SUBJECT: Transmittal of Westinghouse Responses to US NRC Requests for Additional Information on the AP1000 Application for Design Certification

AP1000 DESIGN CERTIFICATION REVIEW

RAI Number: 440.173 (Response Revision 2)

Figure 440.173R2 -5

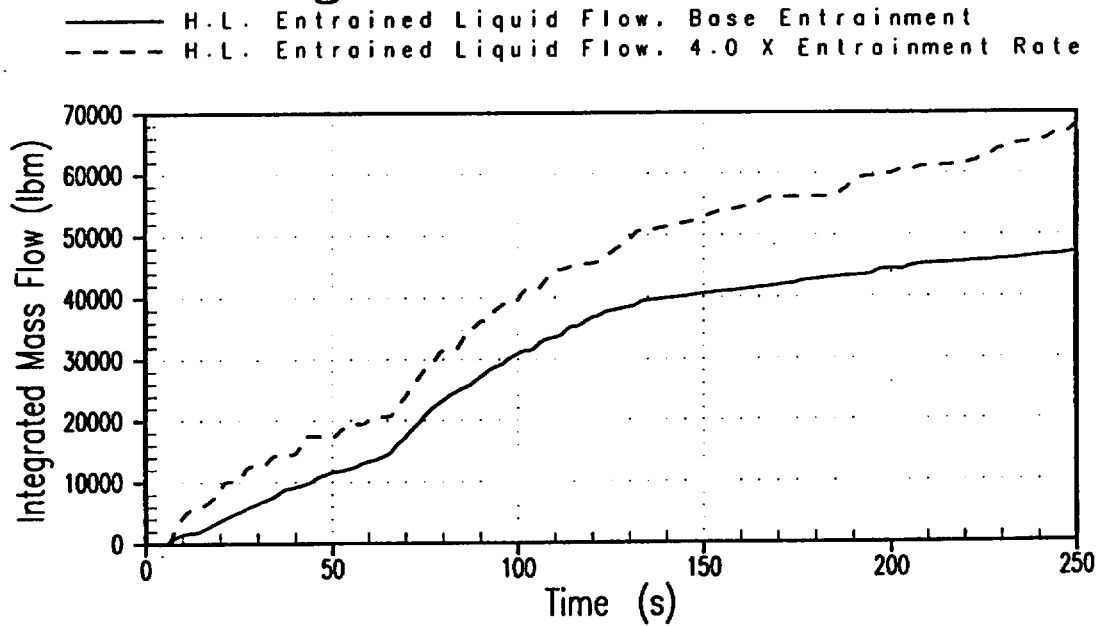
In the 4.0*Entrainment case however, de-entrainment plays a more important role in maintaining a level in the upper plenum. The Gap flows to the hot legs consist mainly of entrained drops. The continuous liquid flow is small with several "spikes." At least periodically, liquid now falls back into Channel 47 as entrained drops. (With the scale in Figure 440.173-18e, it is difficult to determine if the flow rate is zero or a small negative value for $t > 130$ seconds.)

The impact of the calculated upper plenum entrainment rate upon these two cases is small because up until 125 seconds, the total liquid mass flow rates out the hot legs are approximately equal. The integrated flows of the entrained fields from the two cases are shown in Figure 440.173R2-5. Figure 440.173R2-6 shows that up to 70 seconds the higher entrained flow into the hot legs in the [4 x rate] case results in increased back flow of continuous liquid to the upper plenum. Up until 125 seconds, the higher entrained flow in the [4 x rate] case is offset by the greater continuous liquid field flow into the hot legs in the base case (Figure 440.173R2-6), so the total liquid flow rates into the hot legs are approximately the same. The upper plenum masses are also about the same at 125 seconds. The liquid present in the lower two cells of upper plenum channel 15 is primarily continuous liquid (Figure 440.173R2-7) in the base case, whereas in the [4 x rate] case the liquid content of the lower two cells of channel 15 is mostly entrained droplets (Figure 440.173R2-8). The same condition exists in upper plenum Channel 47 at 125 seconds (Figures 440.173R2-9 and -10). Over the next 15 seconds, the same behaviors occur in both cases in these channels; continuous liquid fractions remain constant or even increase a bit, while the entrained droplet mass decreases markedly. The continuous liquid flow exiting Channel 15 is about zero in both cases (Figure 440.173-14 and Figure 440.173-14e) but the entrained liquid flow continues (Figure 440.173-15 and Figure 440.173-15e). Therefore, as a consequence of which liquid field is present, the base case retains most of its upper plenum liquid over the 125-140 second time span, but the [4 x rate] case upper plenum liquid inventory is reduced somewhat. Flow through gaps 21 and 24 into the hot legs is

Figure 440.173R2-13

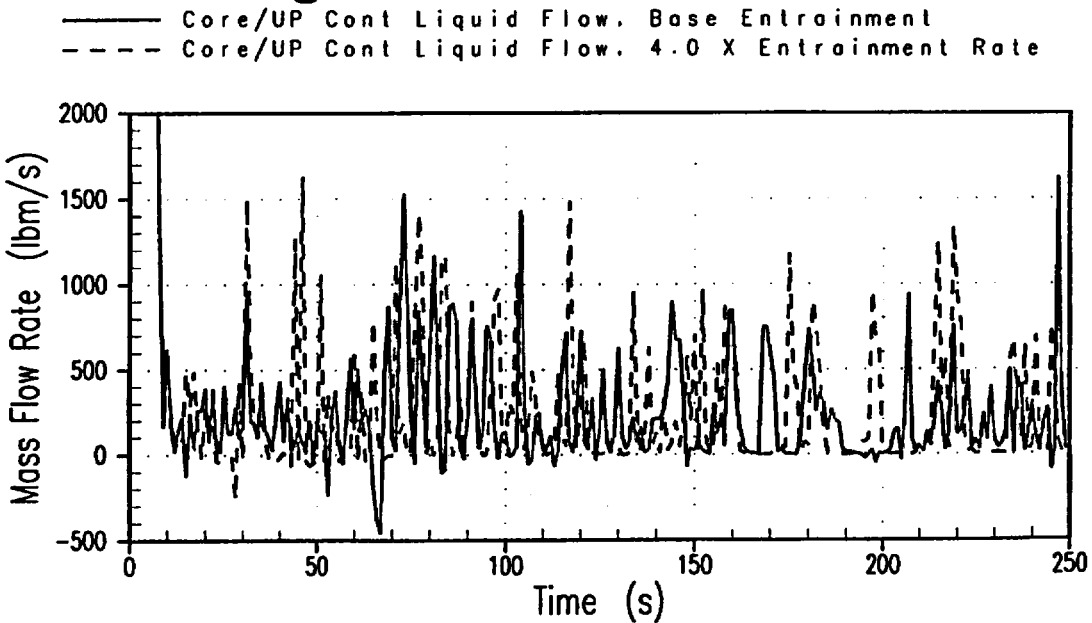
Is the sensitivity to entrainment small because the net effect is negated by additional de-entrainment? If not, please provide justification that the de-entrainment fractions observed in these sensitivities is adequate. In addition, please provide information on flow from the core to the upper plenum. The flow has considerable oscillation, and conditions in the upper plenum may depend more on the process of continuous liquid flow at the top of Channel 10 rather than on the upper plenum region calculations. Include a figure of the collapsed liquid level in the core, in your response.

The core continuous liquid flow rates into the upper plenum are compared in Figure 440.173R2-13, and an integral comparison plot of these flow rates is shown as Figure 440.173R2-14. The values from the base case and the [4 x rate] case are very similar over the course of the ADS-4 IRWST initiation phase transient until IRWST injection is established at 170 seconds. It does not appear that the entry flow from the core is dictating the predicted mass inventory behavior in the upper plenum in these cases.
